A Notice of Deficiency (NOD) for the Operable Unit (OU) 1130 RCRA Field Investigation Work Plan was received by the Department of Energy Los Alamos Area Office (DOE-LAAO) on February 8, 1994. The enclosed Los Alamos National Laboratory NOD response satisfies the required thirty day response period. Certification of the NOD response by DOE-LAAO and the University of California is also enclosed. In the NOD response, deletions to original text are indicated by strike-throughs and additions are indicated in bold.

Response to Notice of Deficiency Concerning Operable Unit 1130 Field

LIST OF DEFICIENCIES, DISCUSSION, AND
PROPOSED TEXT CHANGES
RFI WORK PLAN FOR OPERABLE UNIT 1130

Figure 3-7. Groundwater flow in the main aquifer and water wells in the vicinity of OU 1130.

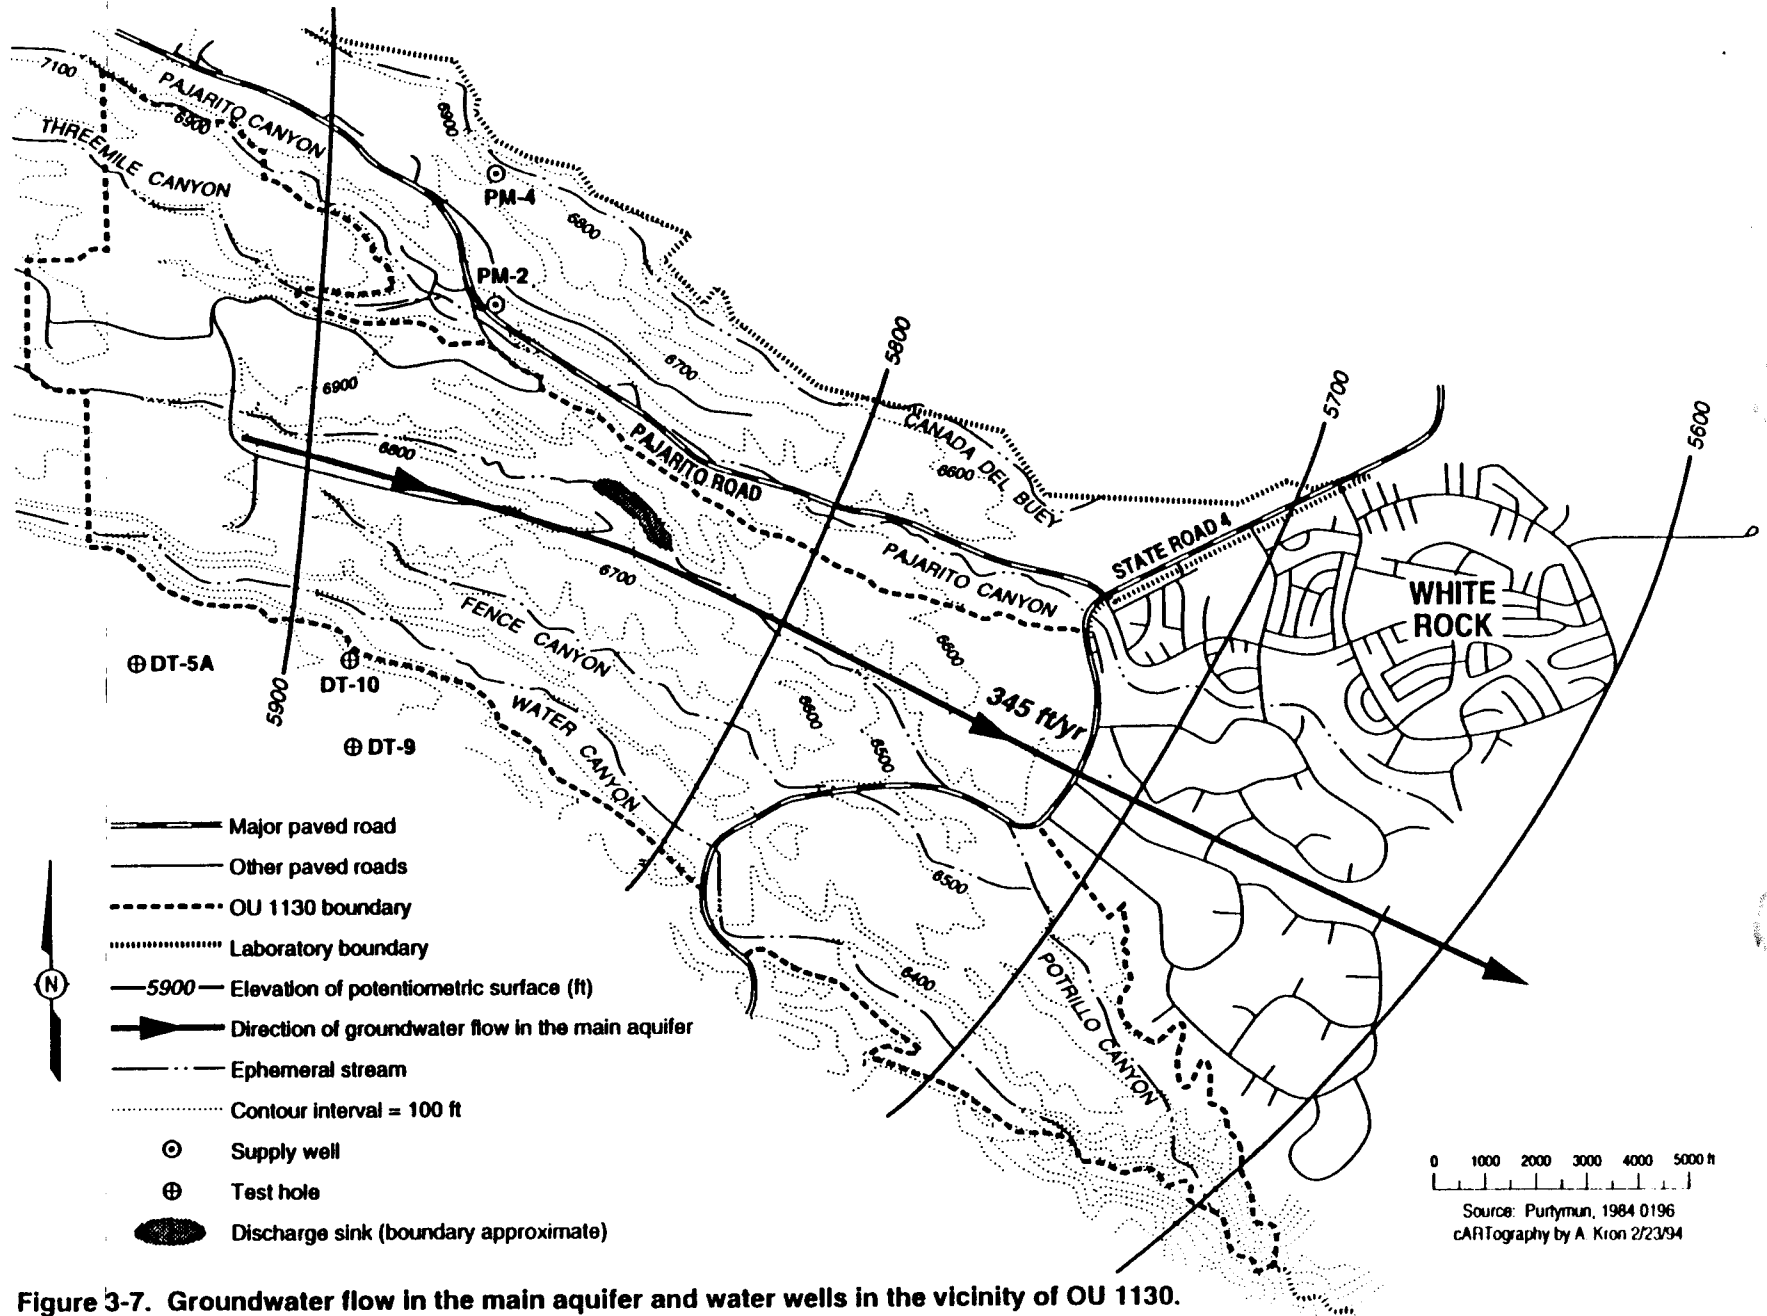
2. 3.5.1.2 Infiltration of Surface Water, p. 3-23

Figure 3.7 does not show the location of the discharge sink in Potrillo Canyon as mentioned in the text. LANL should provide a revised figure showing the location of this sink.

Figure 3-7 has been revised to show the location of the discharge sink in Potrillo Canyon.

Substitute revised Figure 3-7.
